Date: 13<sup>th</sup> April 2021

**Re: South West Milton Keynes, Updated Transport Assessment**

**Location: Land South Of The A421 West Of Far Bletchley North Of The East West Rail Link And East Of Whaddon Road Newton Longville**

**Junction 1: Sherwood Drive/Water Eaton Road/B4034 Buckingham Road – Mitigation Proposal**

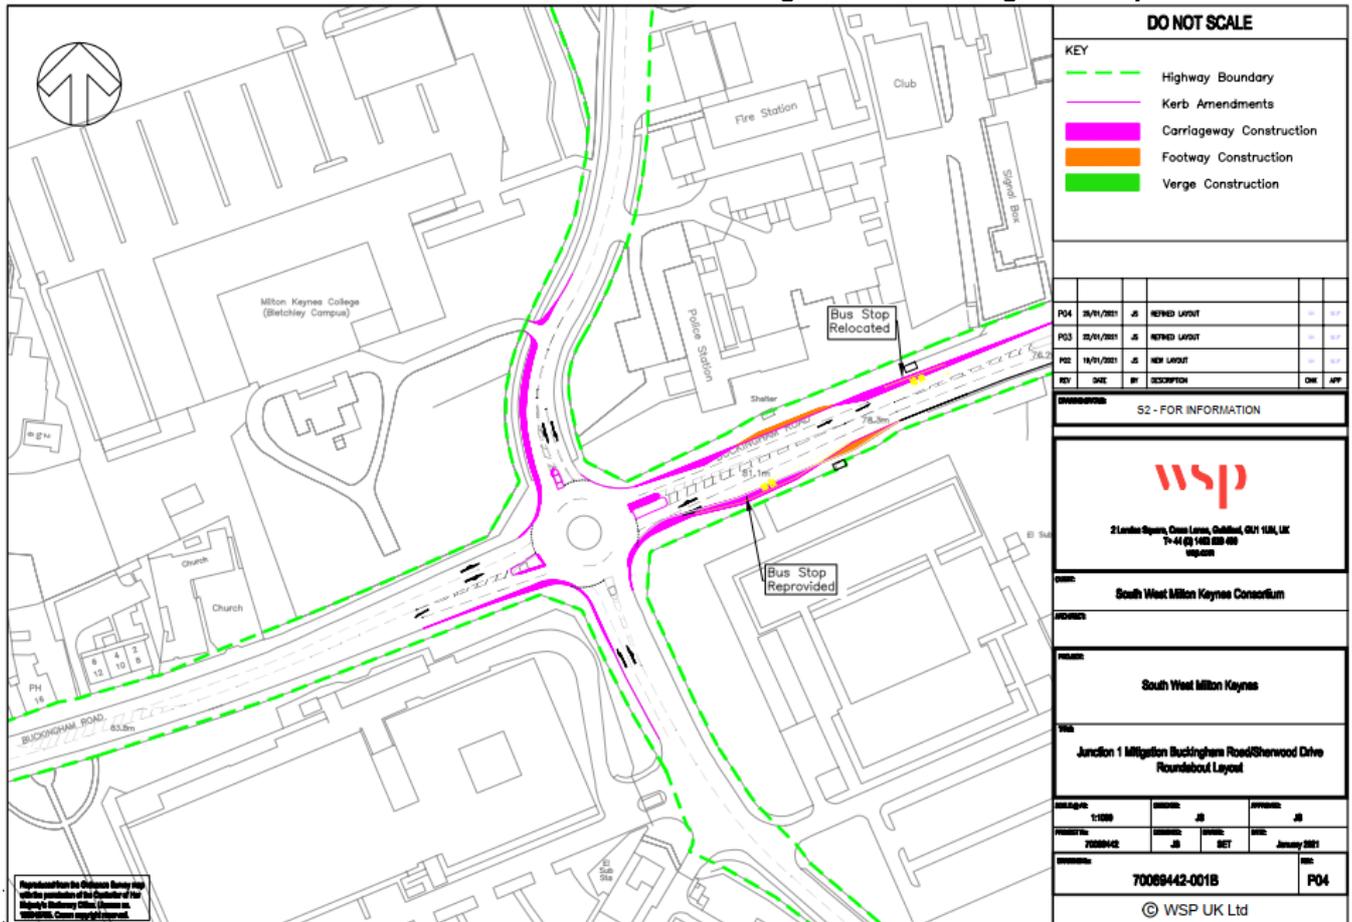
The predicted decrease in capacity due to development traffic would be considered significant and the Applicant has submitted a mitigation scheme. This includes providing two straight ahead lanes on the Buckingham Road (B4034) arms of the junction and minor kerb amendments to the Water Eaton Road and Sherwood Drive arms. To allow for two lane exit on the Buckingham Road (East) the bus stop layby on the north side of road has been replaced with an on-carriageway stop.

Buckinghamshire Council raised concern over the apparent new footway width on Buckingham Road (E) on the southern side is narrowed to accommodate the revised bus stop location. A site visit was performed to measure existing footway widths on the southern side of the road either side of the junction, some discrepancy was noted between the OS plan used as basis for design and the current layout, with variations between 0.4 and 1.8 metres. This may result in the footway behind the bus stop being in the region of 1.5 metres. This concern was provided as part of ongoing application discussions and the Applicant responded by formal letter dated 7th April 2021, this resolved that a width of 1.5 metres would be compliant with the Department for Transport's Inclusive Mobility<sup>1</sup> as the minimum acceptable footway width to enable a wheelchair user and a walker to pass one another. The Applicant also stated that further assessment would be completed at the detailed design stage and subject to finalising the s278 agreement. Whilst the actual resultant footway width will not be known until detailed design is performed the potential conflict point is noted for future consideration.

**Junction 2: Shenley Road/Newton Road/B4034 Buckingham Road – Mitigation Proposal**

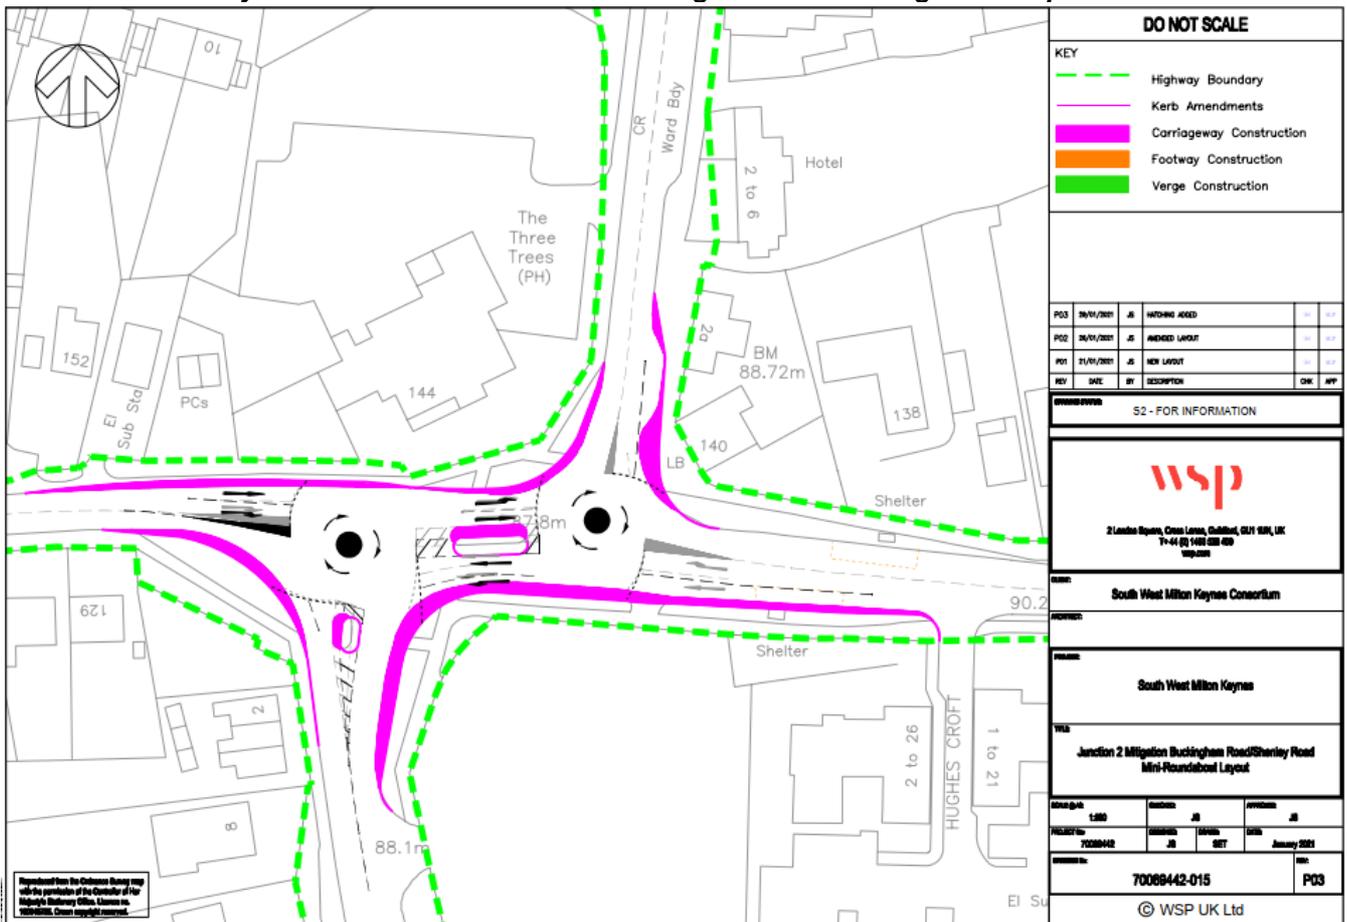
The predicted decrease in capacity due to development traffic would be considered significant and the Applicant has submitted a mitigation scheme. This includes kerb widening on all arms of the mini roundabout to improve capacity. To allow for two lane entry on Shenley Road the existing short layby (covered by no waiting at any time restrictions and hence not used for parking) would need to be removed.

**Junction 5: Tattenhoe Roundabout – Mitigation Proposal**

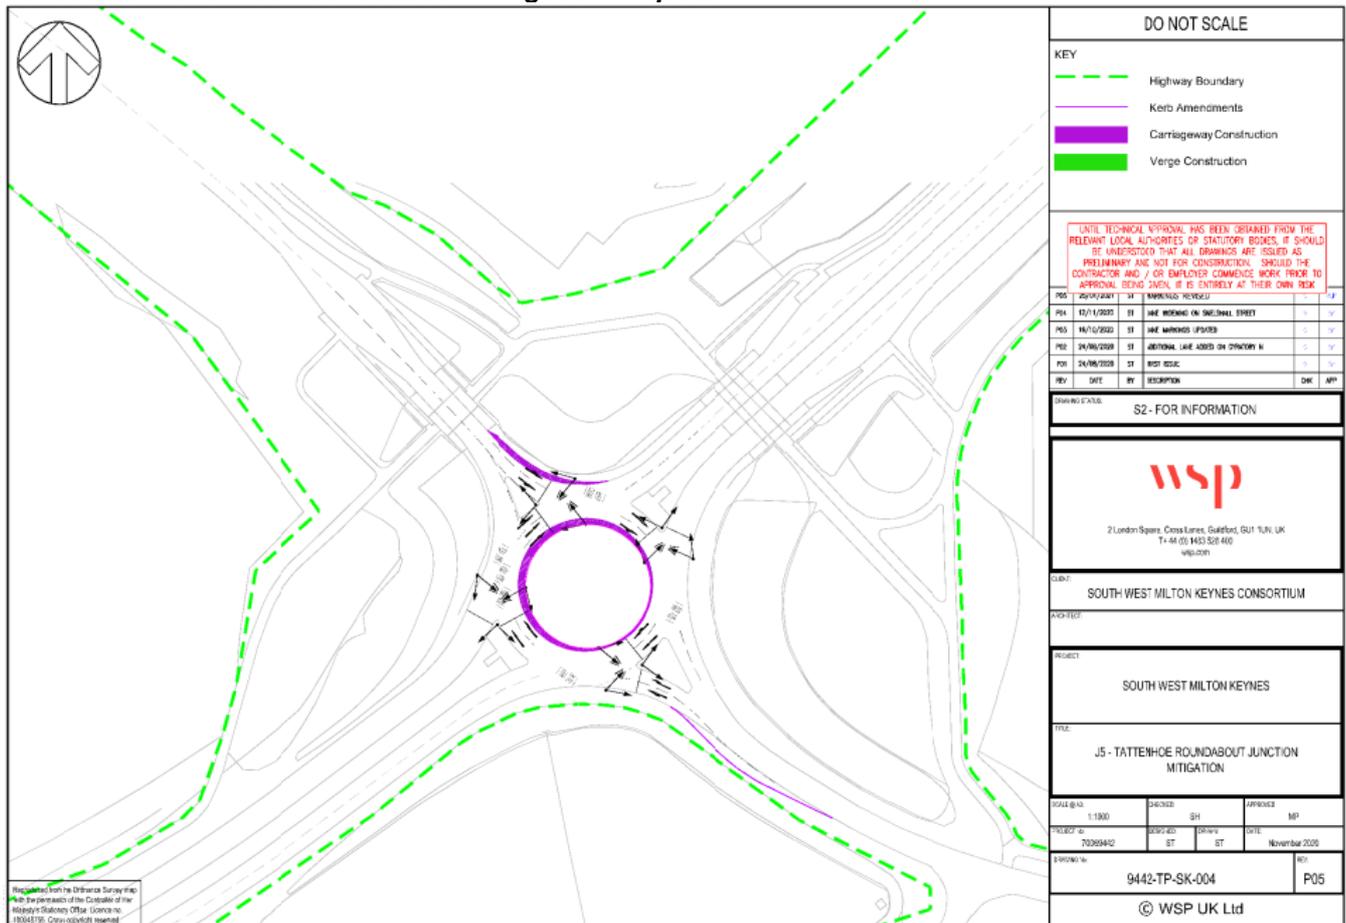
The predicted decrease in capacity due to development traffic would be considered significant and the Applicant has submitted a mitigation scheme. This includes altering the junction to 'part-time' traffic signals that would operate at peak periods with flare extended on Buckingham Road to provide greater stacking space. The central island would also be slightly narrowed to better accommodate two-lane straight-ahead and turning movements.

**Junction 6: Bottledump Roundabout – Mitigation Proposal**

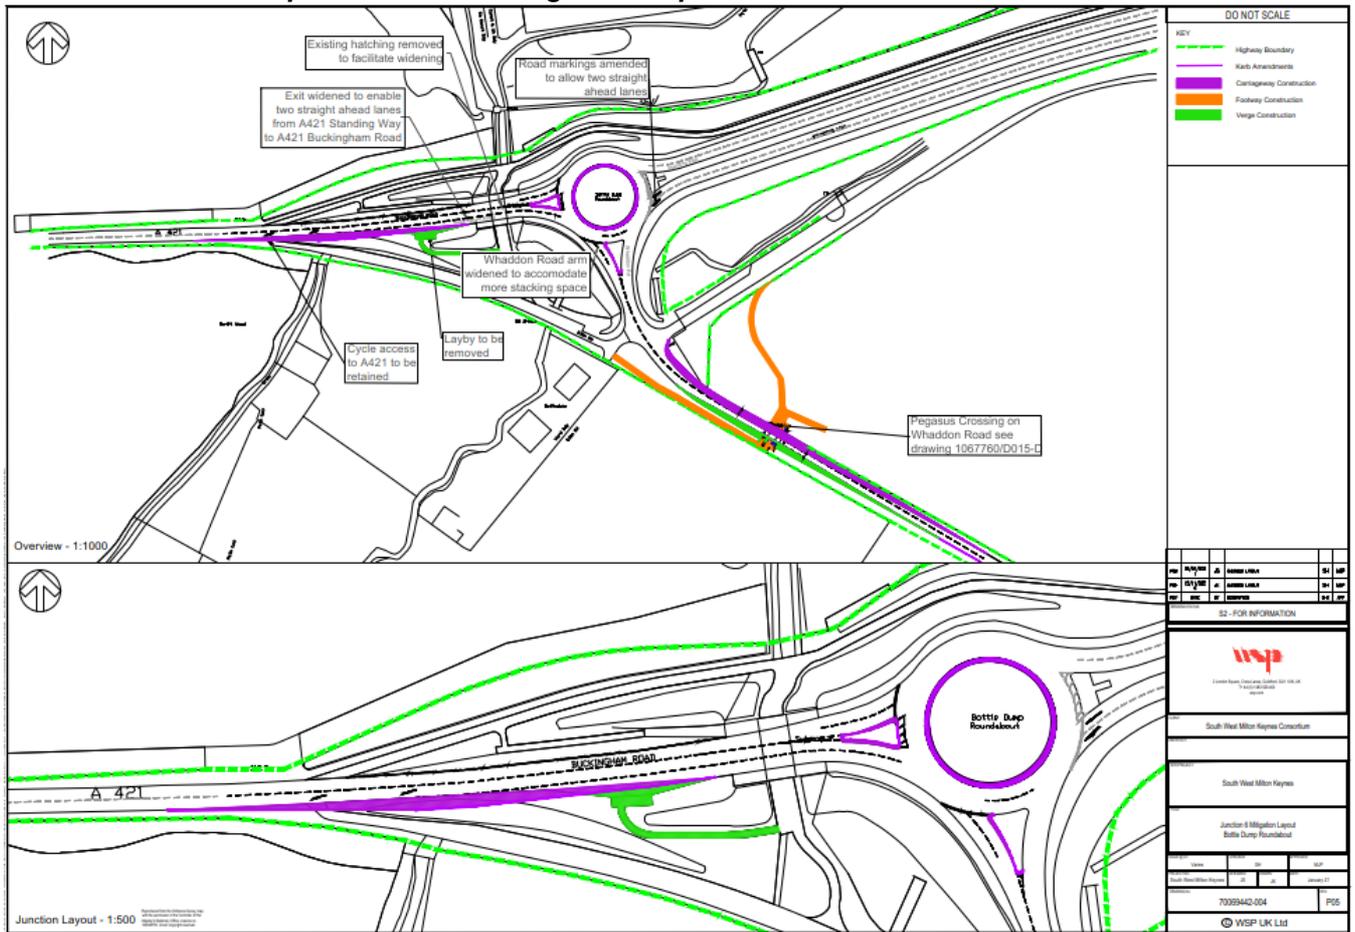
The predicted decrease in capacity due to development traffic would be considered significant for the A421 Standing Way and Whaddon Road and the Applicant has submitted a mitigation scheme. This includes widening the Buckingham Road exit to two lanes for an extended length to allow straight ahead movements from both lanes on A421 Standing Way, this would require a reduction of the flare available on A421 Buckingham Road. Furthermore, Whaddon Road would be widened slightly and the central island narrowed to better accommodate two lane straight ahead movement. A new Pegasus crossing is also proposed on Whaddon Road south of the junction.

**Junction 12: Kingsmead Roundabout – Mitigation Proposal**

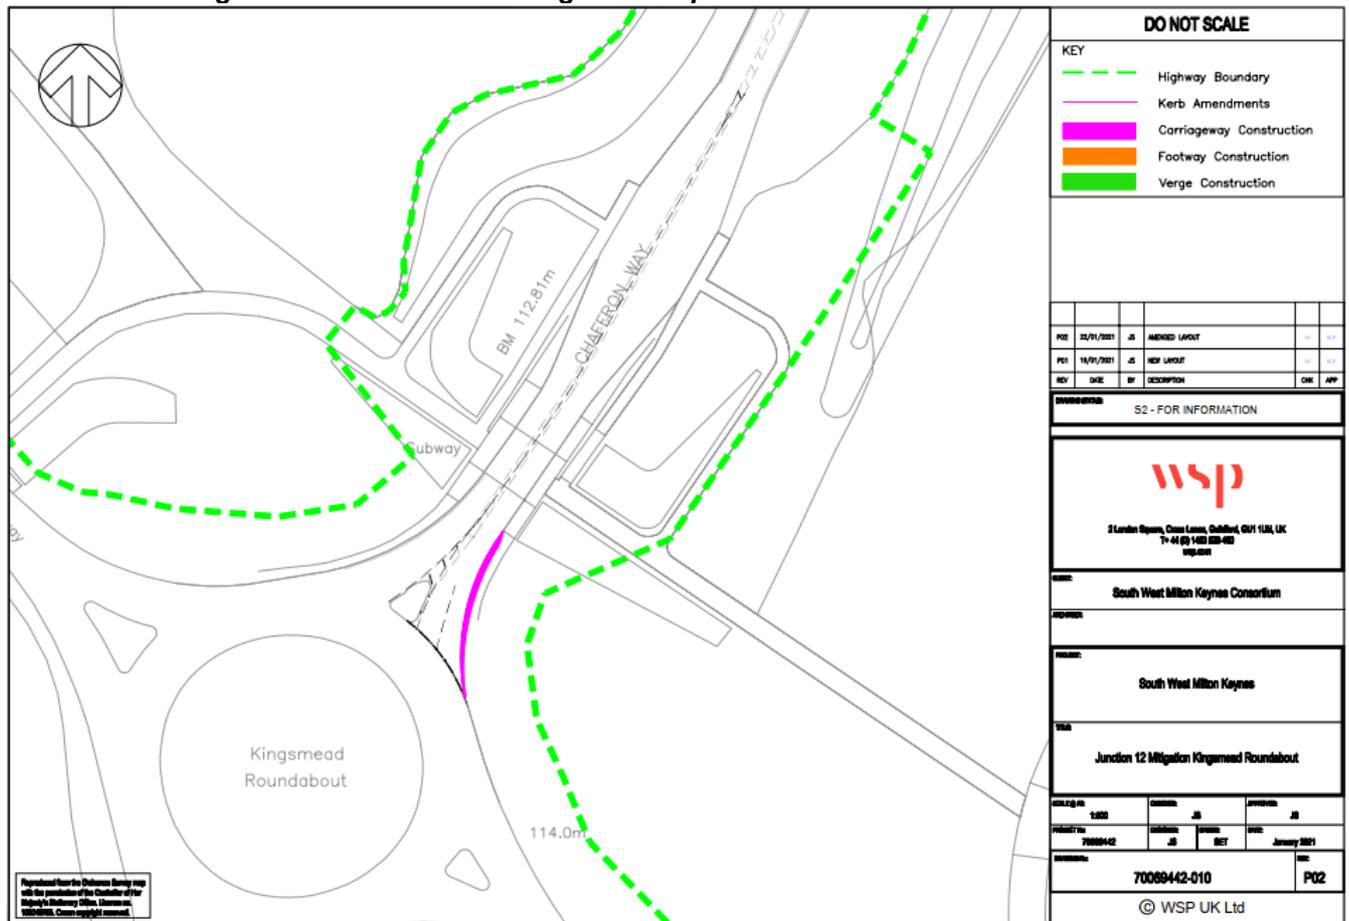
The predicted decrease in capacity due to development traffic would be considered significant for Chaffron Way and the Applicant has submitted a mitigation scheme. This includes kerb widening Chaffron Way to improve capacity.

**Junction 14: Furzton Roundabout – Mitigation Proposal**

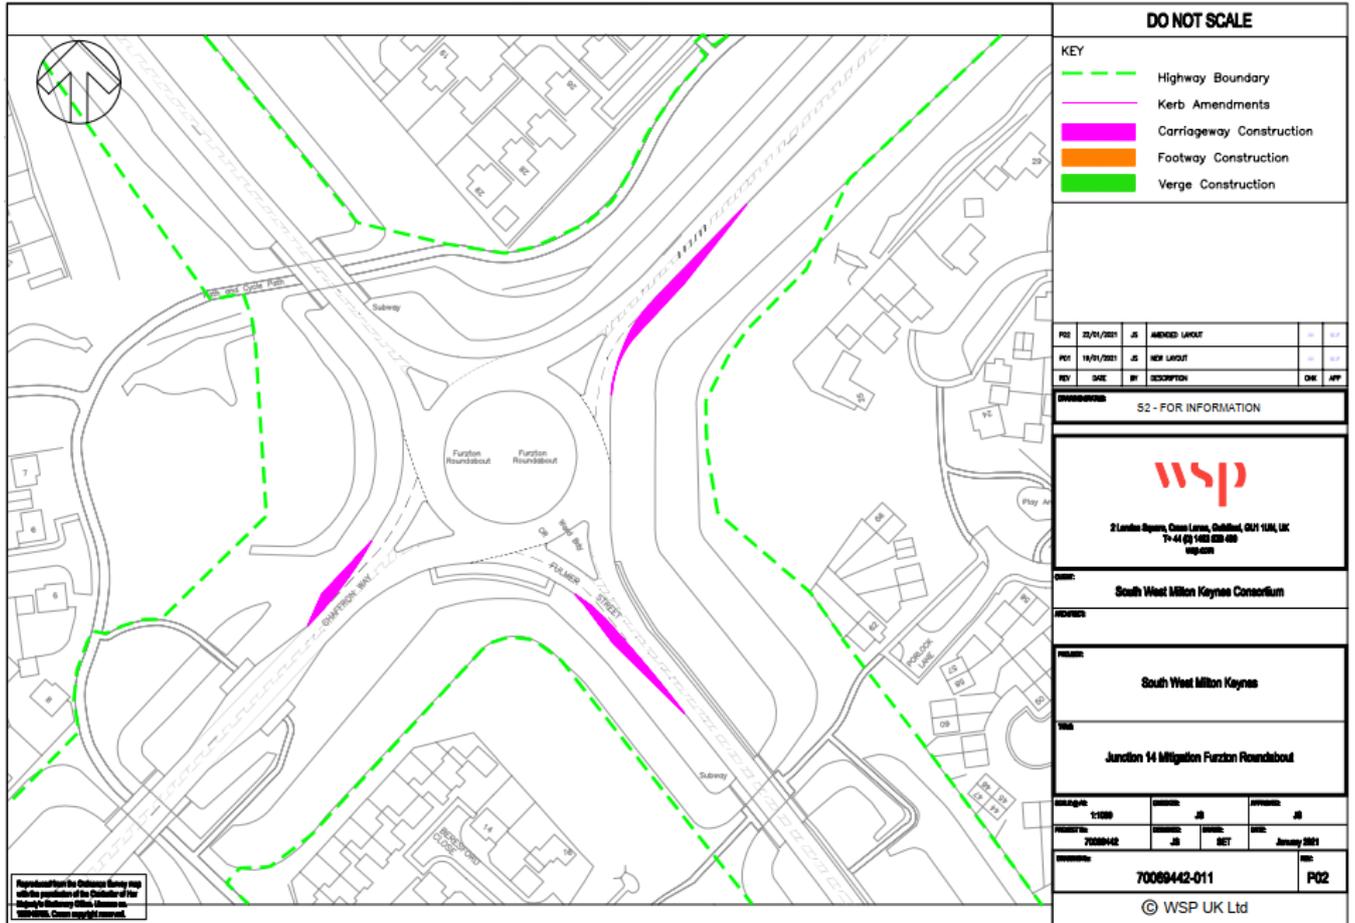
With the addition of the development traffic (DS1) those already poorly performing arms would see further increases in queueing and delay, with the largest increase evident on Fulmer Street (S) in the AM peak and Chaffron Way (E) in the PM peak. The predicted decrease in capacity due to development traffic would be considered significant and the Applicant has submitted a mitigation scheme. This includes kerb widening on Chaffron Way (E) and (W) and Fulmer Street (S) to improve capacity.

**Junction 15: Bleak Hall Roundabout – Mitigation Proposal**

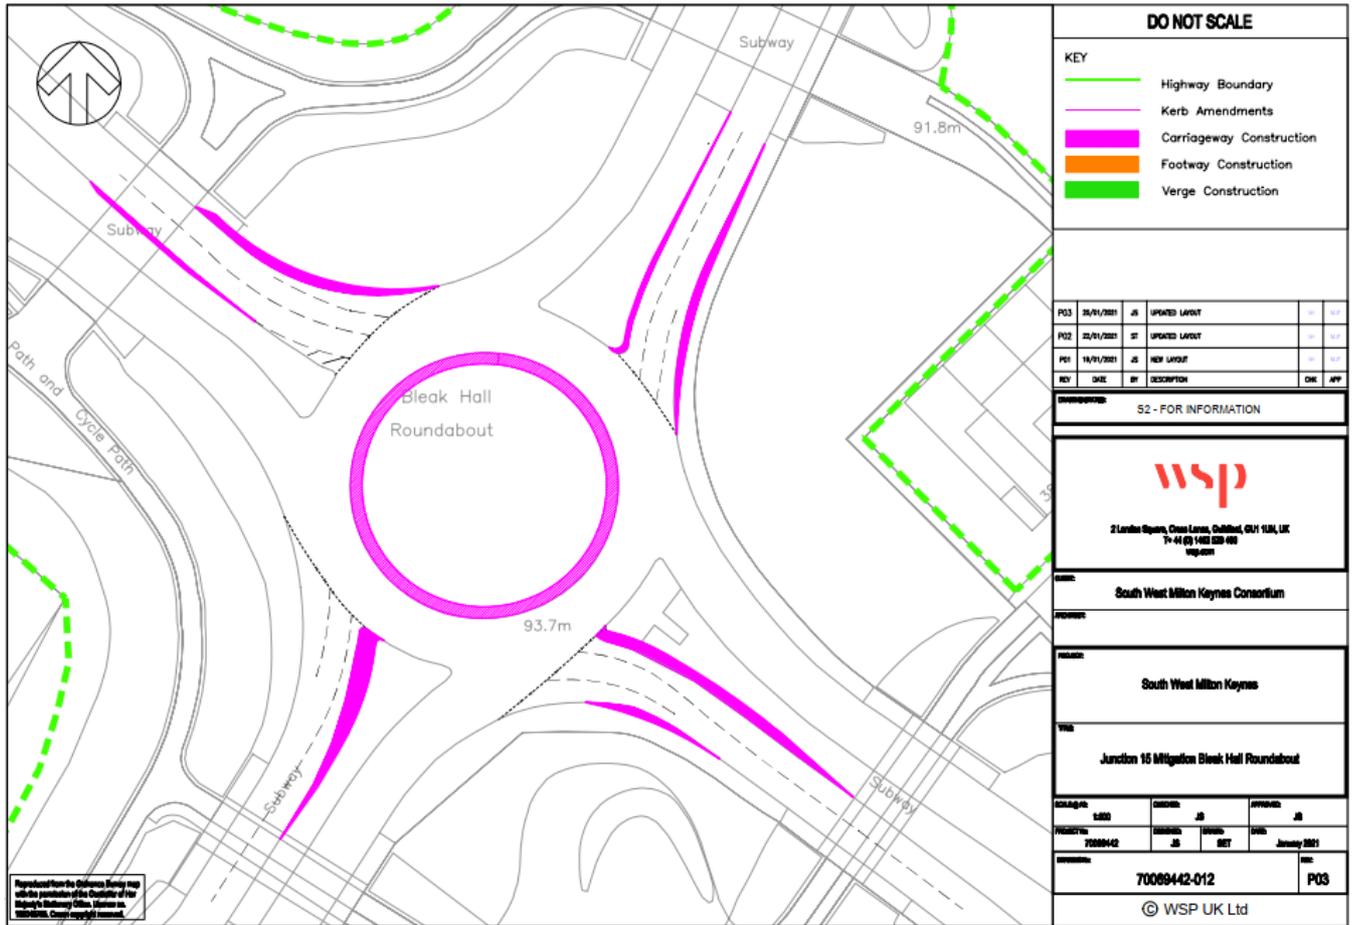
With the addition of the development traffic (DS1) further reduction in capacity is expected with queues now predicting to exceed 300 or close to reaching 400 vehicles with A421 Standing Way blocking back to Junction 16. The predicted decrease in capacity due to development traffic would be considered significant and the Applicant has submitted a mitigation scheme. This includes kerb widening on all arms to improve capacity.

An independent Stage 1 Road Safety Audit has been undertaken and the Council is satisfied that the problems identified can be resolved during detailed design. It is considered that the proposed mitigation scheme offers a viable alternative and is proportionate and reasonably related in scale to the impact of the development, as required by the NPPF with overall improvement in capacity terms. Furthermore, the junction has been identified in two separate Milton Keynes studies (LTP4 Transport Infrastructure Development Plan (TIDP) and MK Multi Modal Model Impacts of Plan MK report, November 2017) as a site for potential capacity improvements due to known capacity issues.
